QUEENSLAND FLOODS COMMISSION OF INQUIRY
REVIEW OF HYDRAULIC MODELLING
FINAL REPORT

REVIEW OF HYDRAULIC MODELLING QUEENSLAND FLOODS COMMISSION OF INQUIRY

Project Review of Hydraulic Modelling Queensland Floods Commission of Inquiry		Project Number 111024
Client QLD Flood Commission of Inquiry		Client's Representative Lisa Hendy
Authors Mark Babister Stephen Gray Rhys Hardwick Jones		Prepared by 
Date 28 JULY 2011		Verified by 
Revision	Description	Date
1	FINAL	JULY 11
2	FINAL (Revised 28/07/11)	JULY 11

Figure 11: Flow chart describing the derivation of All upstream Mt Crosby Input Hydrograph

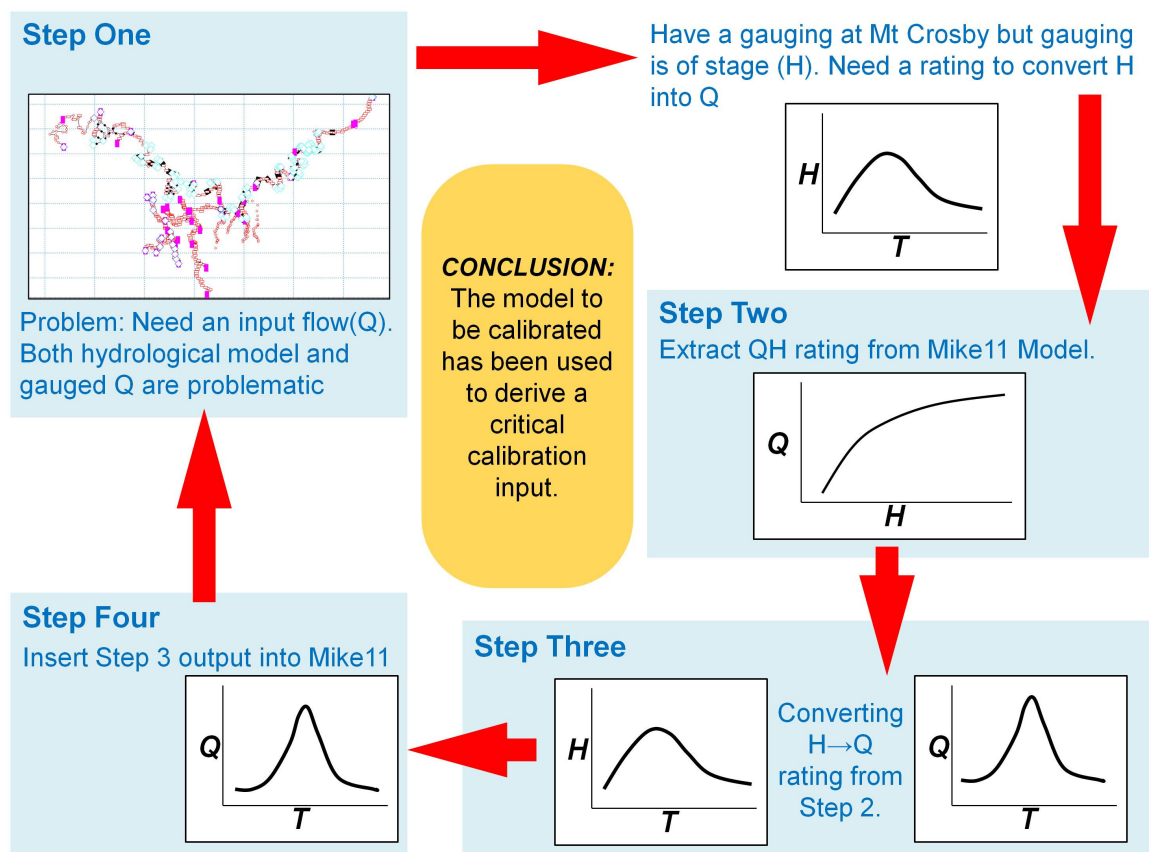
- 52 **Boundaries** – Whilst the model domain includes the Brisbane River up to the outlet of Wivenhoe Dam the January 2011 event does not include tributary inputs such as Lockyer Creek inflows and other local inputs. Instead a lumped accumulation of inputs upstream of Mt Crosby Bridge (minus Wivenhoe flow), has been back calculated based on a Mike11 derived rating for the Mt Crosby stream gauge. Figure 11 describes the process and its inherent circularity i.e. the model to be calibrated is used to derive a key calibration input. Also the use of Mt Crosby as a major boundary is non-ideal because it doesn't allow for the adequacy of the model upstream of Mt Crosby to be assessed during the calibration. The same approach could presumably have been carried out at Lowood, approximately 50 kilometres up river, extending the overall portion of the model useful for analysis and interpretation.
